PROPOSED CHANGE ORDER REQUEST

Contract Name: Snapfinger Advanced Wastewater Treatment Facilities Date: 4/24/2018
Expansion- Phase 2

Subject: Proposed Change Order #1

Proposed Change Order # 007B
Pipe Encasement per Submittal Comments

ADVANCED WASTEWATER TREATMENT FACILITIES EXPANSION
SNAPFINGER PHASE 2
HEADWORKS FACILITY
LOWER LEVEL PLAN

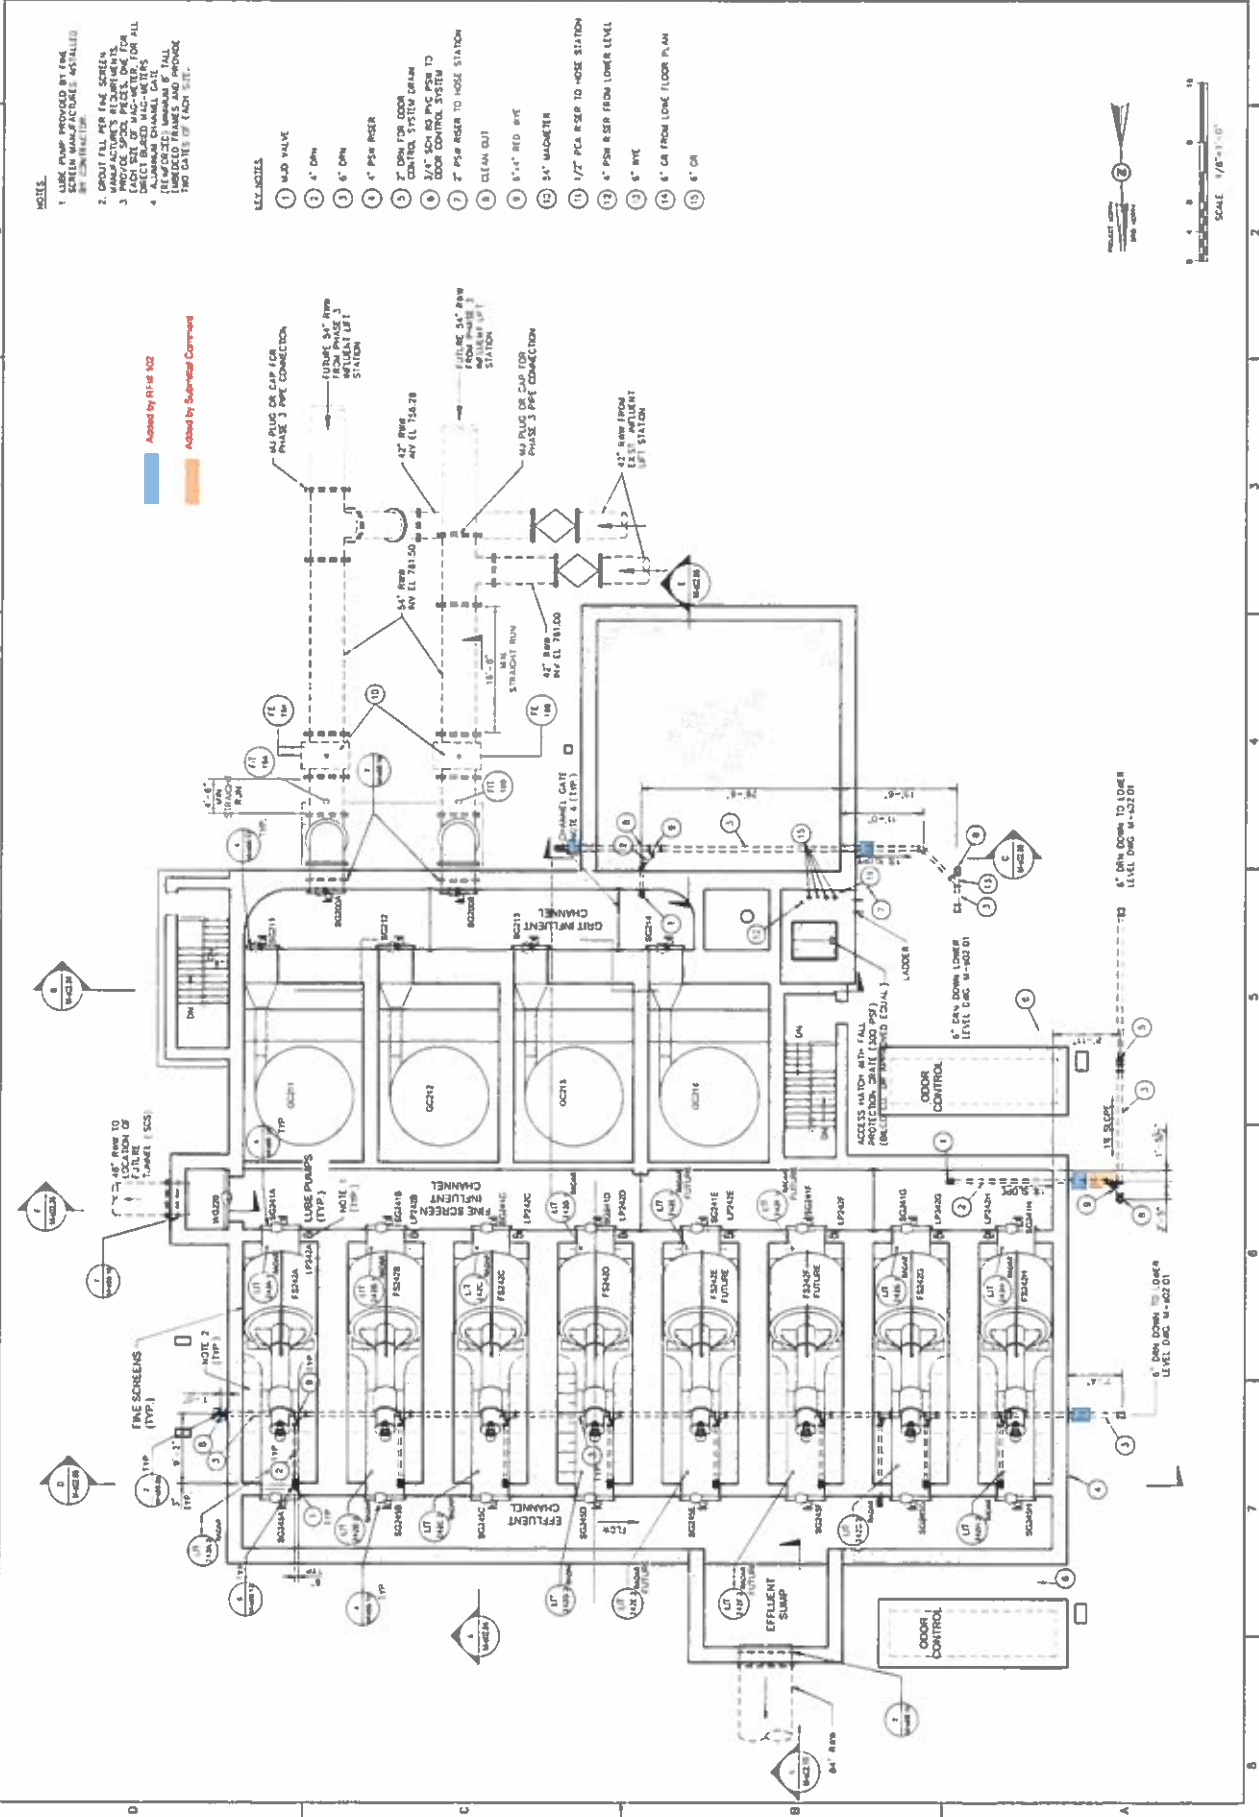
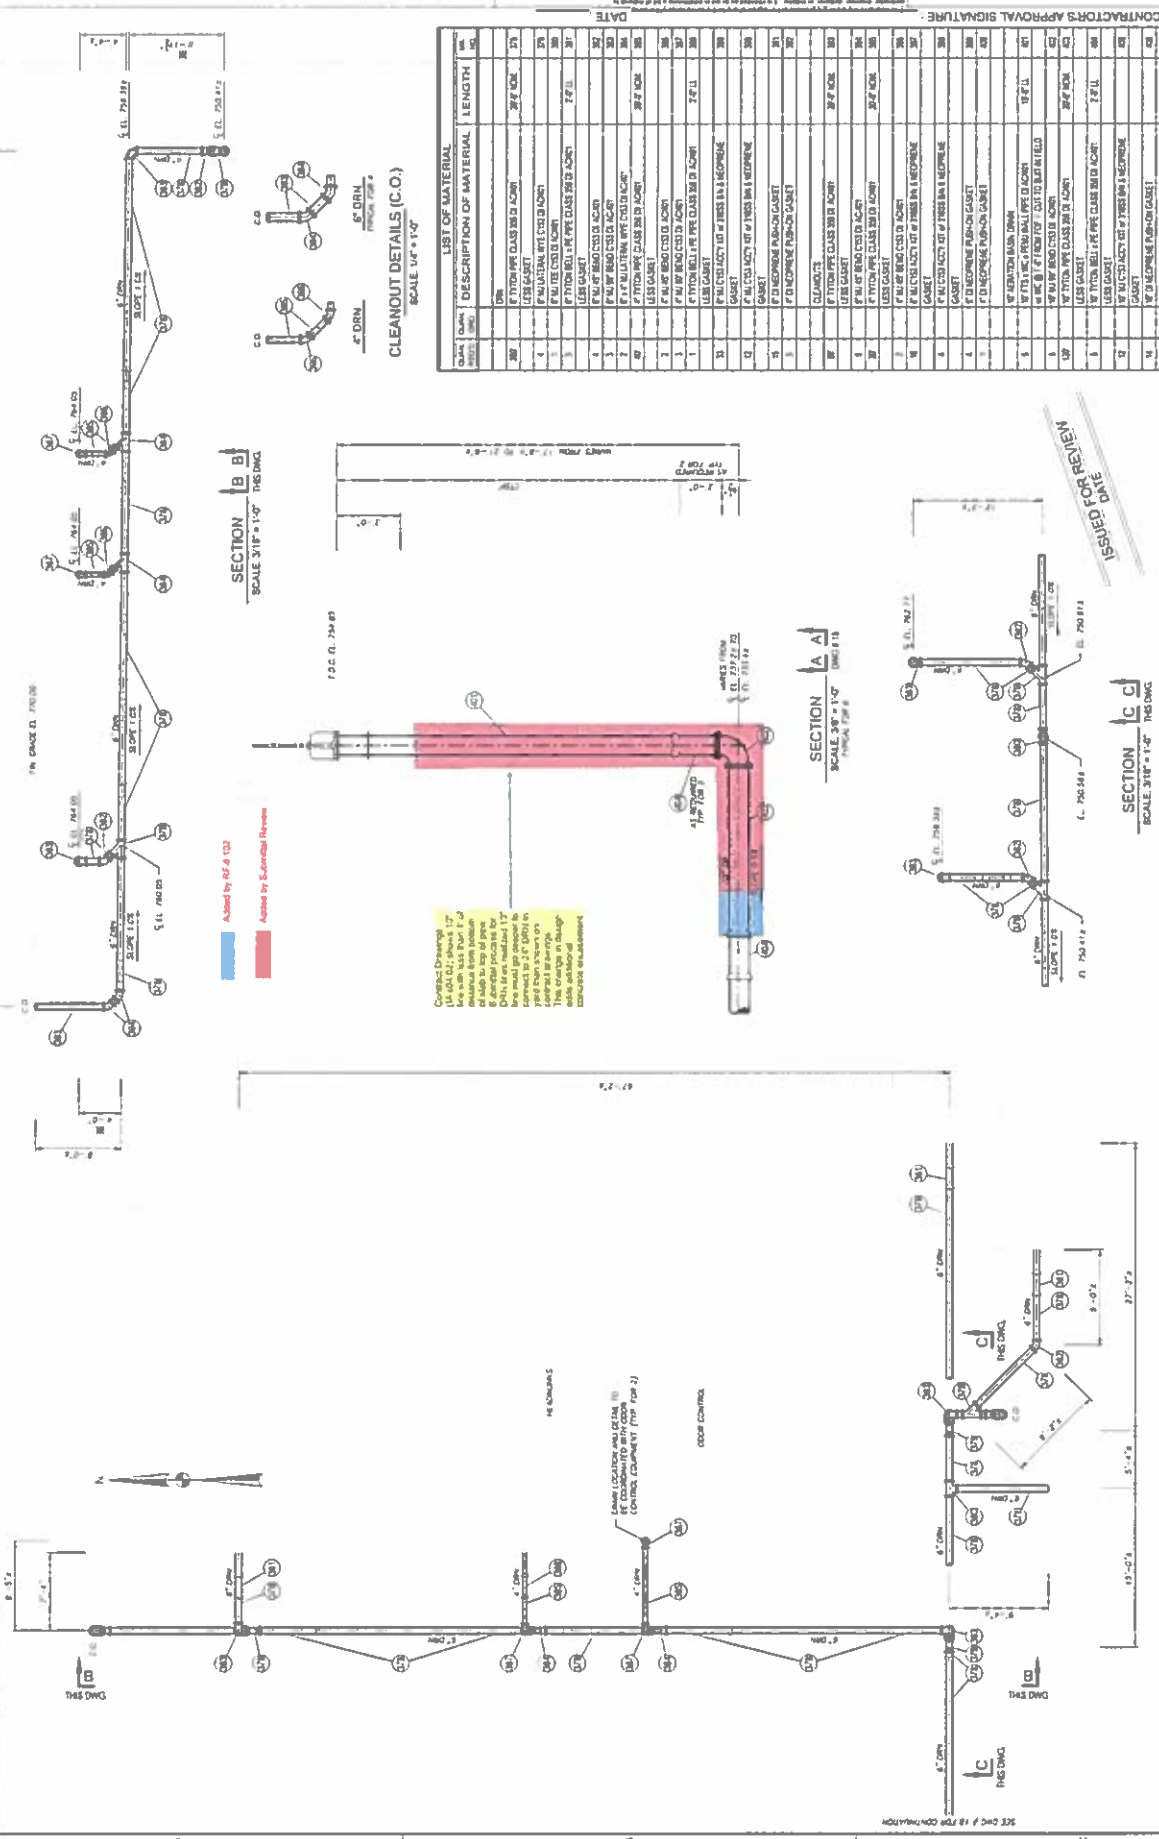
Unlike the remaining structures on the project that either show pipe encasement or reference the specific encasement details that is to be used, the above referenced drawings clearly show no pipe encasement.

The note that you are referencing is shown on drawing M-s.02.01 and it is note 3 out of 6 total notes on that drawing. Drawing is titled " Headworks Facility Lower Level Plan" and most of these 6 notes are specific to this particular drawing with only one Note #5 starting with: "General note for all Mechanical Drawings:...". It is not implied or stated anywhere on the referenced drawing, or within Note 3 that it should be applied on any other structure on the project except for the structure that is shown on. In our case that would be a Headworks Facility only. Such interpretation of the notes of the notes on the contract drawings has been somewhat of a "default standard" to date and your response somewhat broadens horizons of the drawing specific notes interpretation and application.

We would not question notes under " General Mechanical Notes" heading but this is not the same in this particular situation. Could you please clarify how you have concluded that this specific note would all apply to all the structures on the project, especially if we take into a consideration the fact that certain structures clearly identify encasement (and we do not questions those structures) and others clearly do not identify the encasement with no "general" notes for those structures.

Concrete encasement of pipe under slabs is required for all Functional Areas. Please reference Note 3 on the first mechanical drawing, M-s02.01.

MBR- PIPE ENCASUREMENT PLAN VIEW

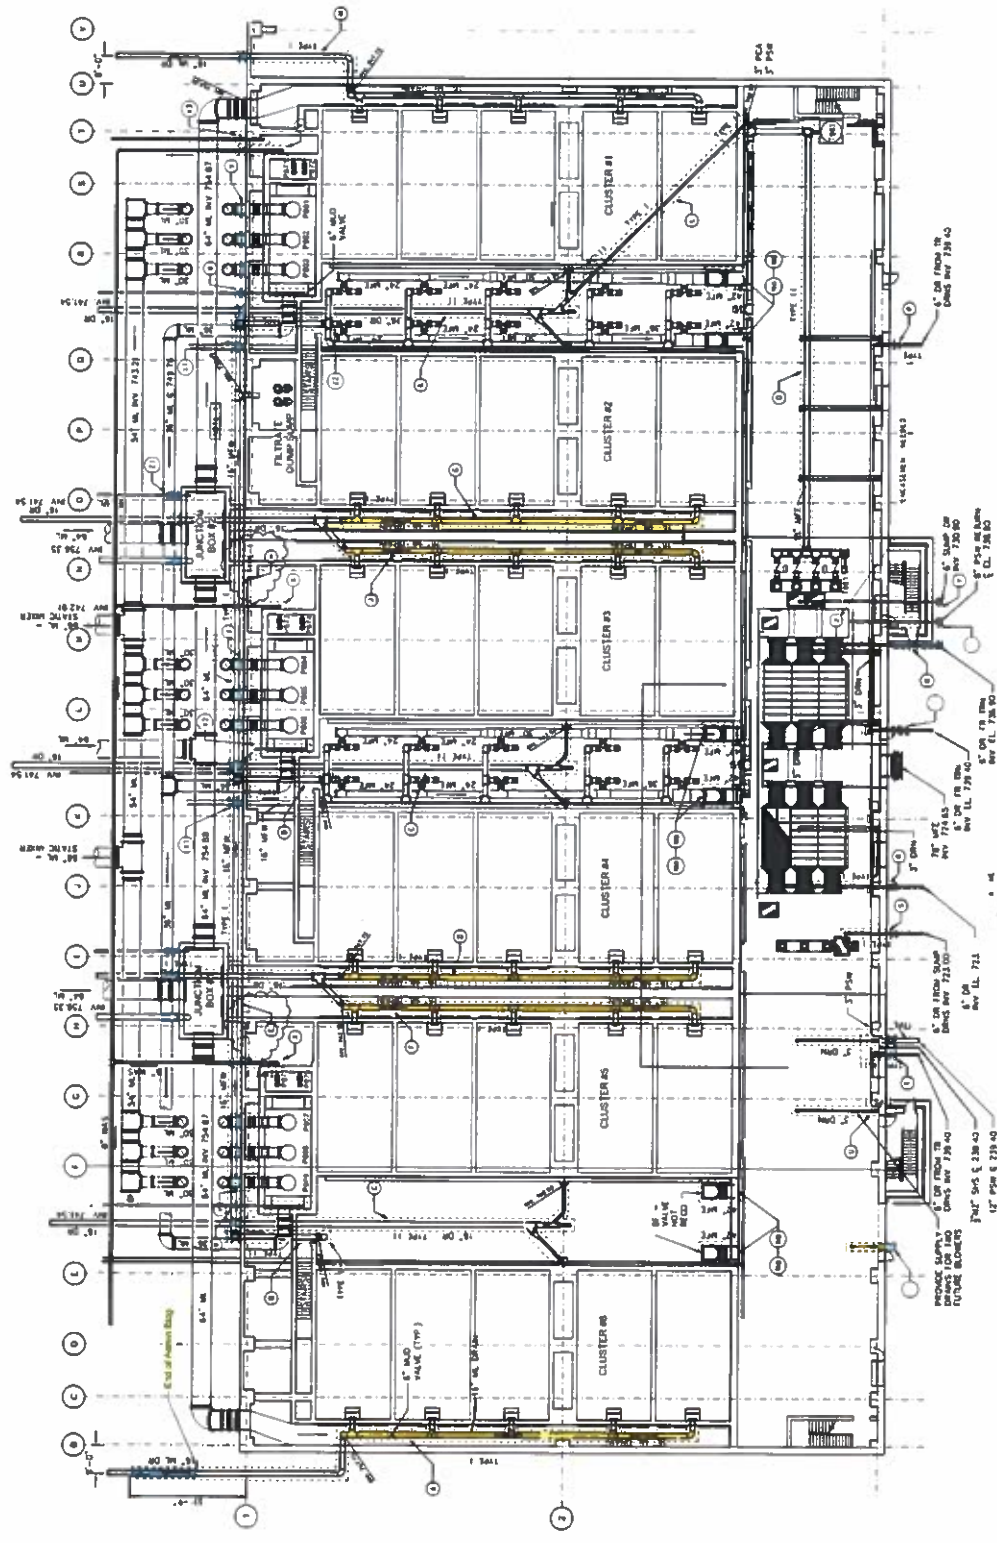
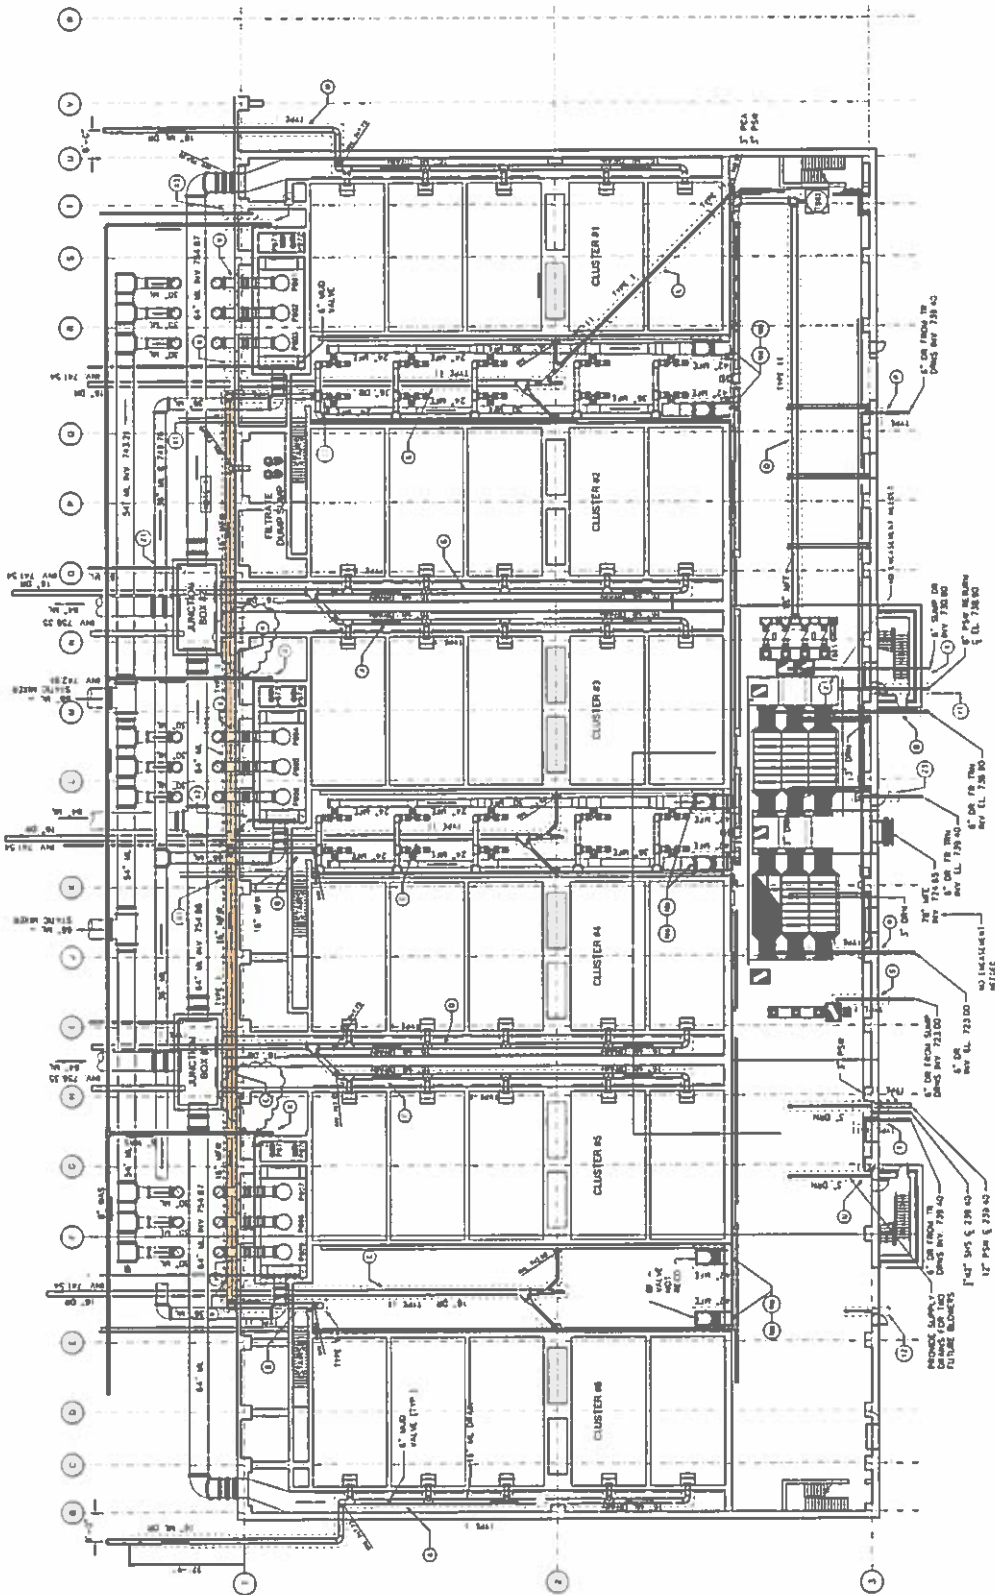
Issued by Submittal Review

Added by Submittal Review

1 SANITARY WASTE AND VENT PLAN
SCALE: 1/4" = 1'-0"
SCALE: 1/4" = 1'-0"

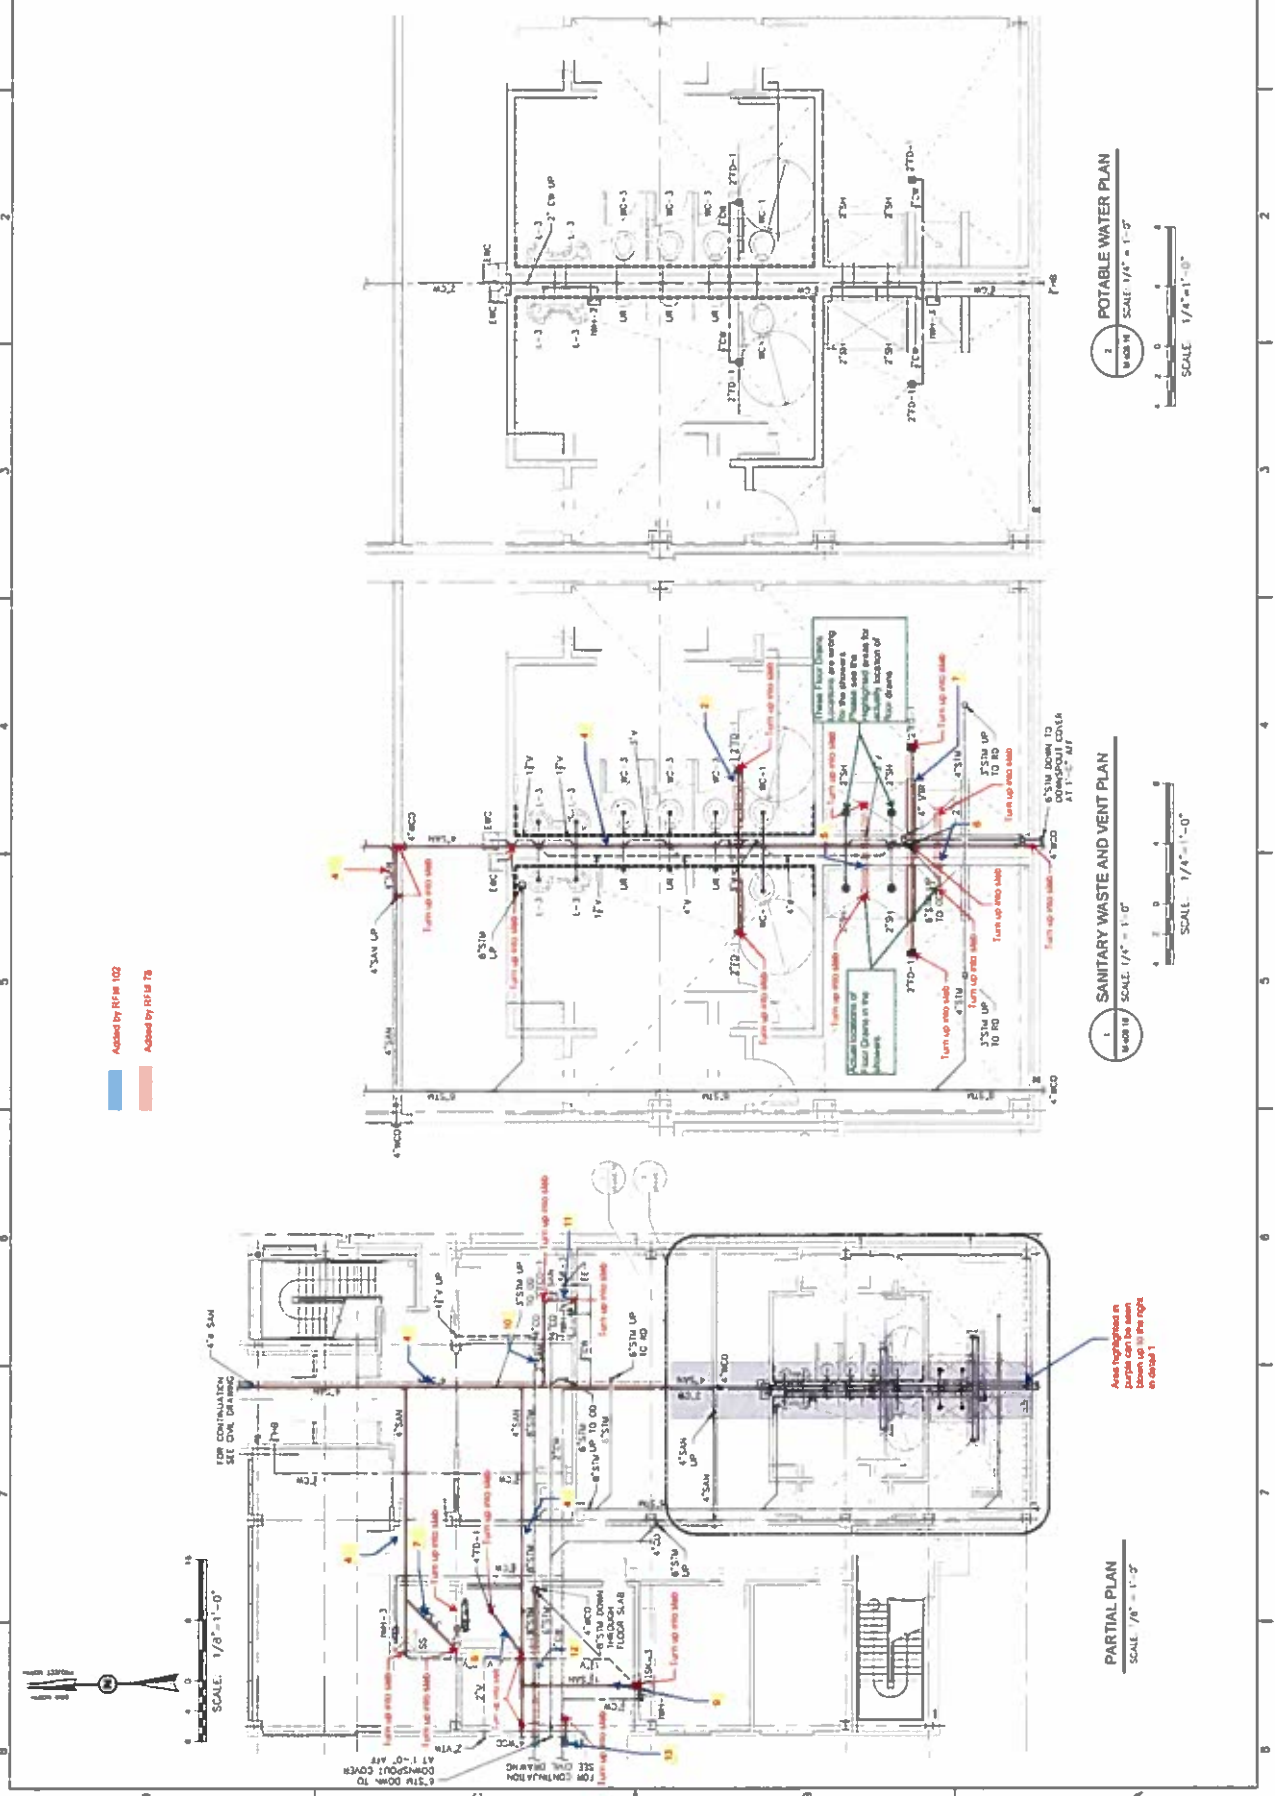
Added by RFP# 102
Added by RFP# 78

Area highlighted in red
is not to be installed
in detail 1
